CUSTOMER NOTIFICATION

SUD-DT-03-0136-1-E (1/6) (SUD-TT-0117-5-E)
March 20, 2003
Koji Nishibayashi, Senior System Integrator Microcomputer Group 2nd Solutions Division Solutions Operations Unit NEC Electronics Corporation

IE-703217-G1-EM1
(Control Code: A, B, C)

Operating Precautions

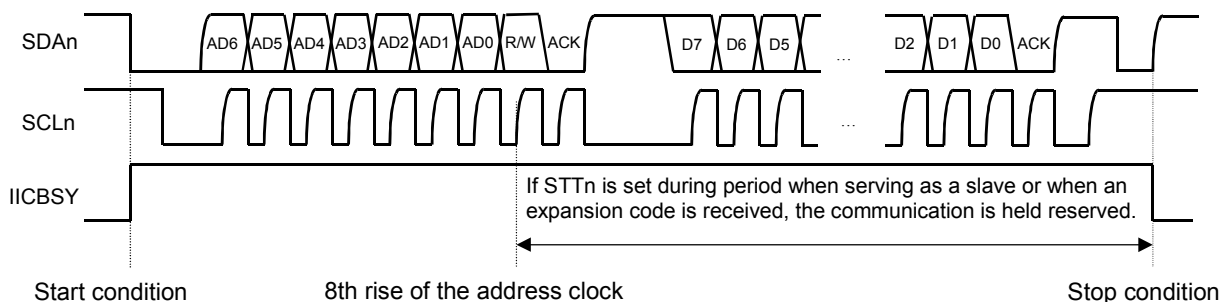
No.5 Restriction on interrupt request flag

The interrupt request flag is not cleared even if an interrupt request has been acknowledged.

Add processing to clear the interrupt request flag at the beginning of the handler address of the acknowledged interrupt. Clearance of the interrupt request flag can be performed by instruction execution.

This restriction has been corrected in control code B.

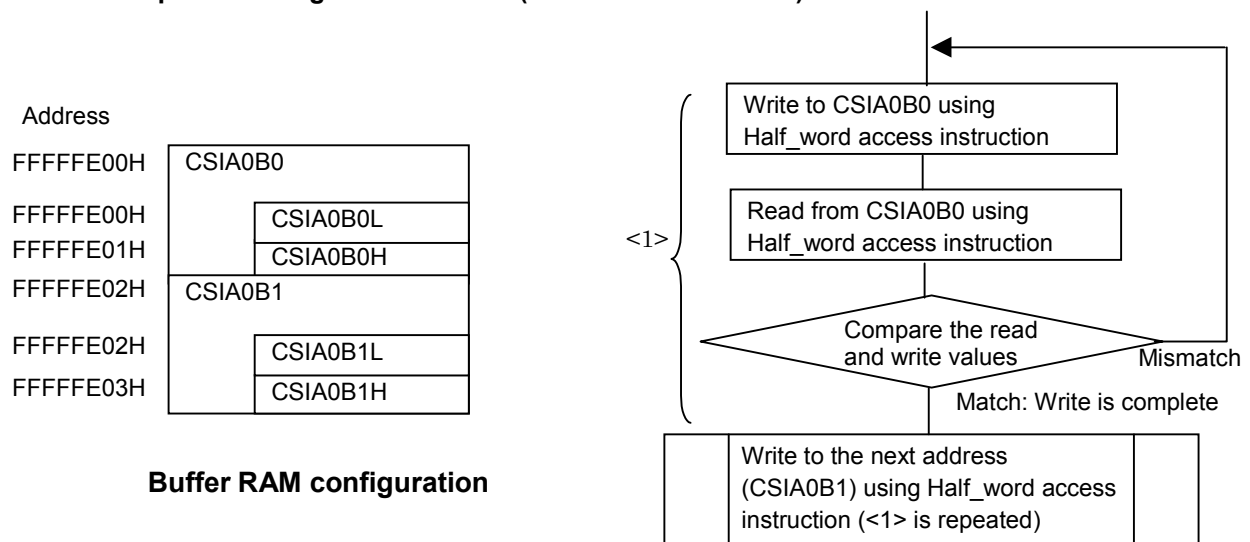
No.6 Restriction on IIC bus communication reservation

If conditions (1) and (2) are satisfied when using the IIC bus interface (IICn), the communication is held reserved even if communication reservation is disabled (IICRSVn = 1). At this time, the start condition clear flag (STCFn) is not set (n = 0 or 1). (See the figure below.)

- (1) When the address value and the slave address register (SVAn) value match or when an expansion code is received
- (2) When the start condition trigger (STTn) is set in the period from the 8th rise of the address clock to stop condition detection.

This bug can be avoided by software.

This bug occurs when the bus flag (IICBSY) is being set. Before generating the start condition (STT_n ← 1) while communication reservation is disabled (IICRSVn = 1), confirm that the IIC bus status flag has been cleared (IICBSYn = 0).

STT_n can be set immediately after IICBSYn = 0 is confirmed, but it is recommended to disable interrupts because if it takes a long time to set STT_n due to an interrupt, the start condition may be detected during the period, and a slave match may occur or expansion code may be received at the 8th address clock.

This restriction has been corrected in control code C.
